# 802.3dj D1.0 Comment Resolution Logic Track

Gary Nicholl (Cisco), 802.3dj Chair, Architecture and Logic Track

# Clause 177, Inner FEC Sync Comment # 505

Figure 177-8—Inner FEC pad detection state diagram

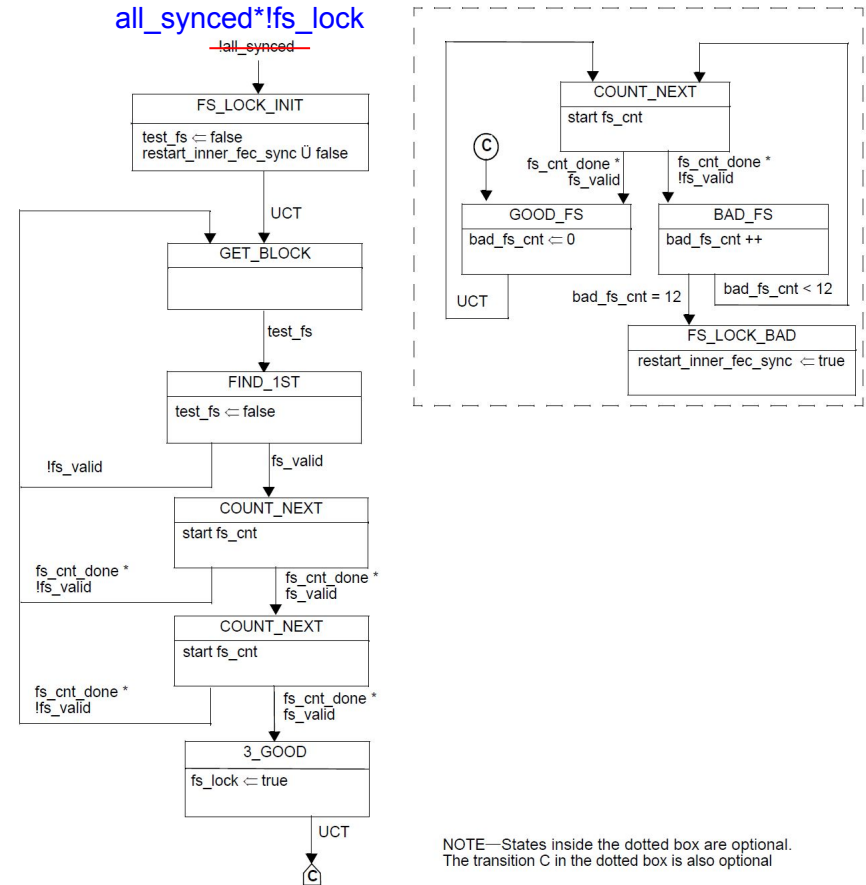
| Cl 177   | SC 177.6  | P 262                  | L 5      | # 505                 |
|--|-----------|------------------------|----------|-----------------------|
| In Figure 177—8, the input variable of state FS_LOCK_INIT is not correct. It would cause a FS lock error.  |           |                        |          |                       |
| FS_LOCK_INIT state should be entered after all the 8 flows obtain their inner FEC codeword boundaries and inner FEC flow 0 is identified, when fs_lock is false.   |           |                        |          |                       |
| Propose change:<br>Change the input variable from '!all_synced' to 'all_synced * !fs_lock'.  |           |                        |          |                       |

| Cl 177   | SC 177.6  | P 262                  | L 5      | # 505                 |
|--|-----------|------------------------|----------|-----------------------|
| Change the condition for FS_LOCK_INIT state from "!all_synced" to "all_synced*!fs_lock"  |           |                        |          |                       |

Change Figure 177-8 as follows:
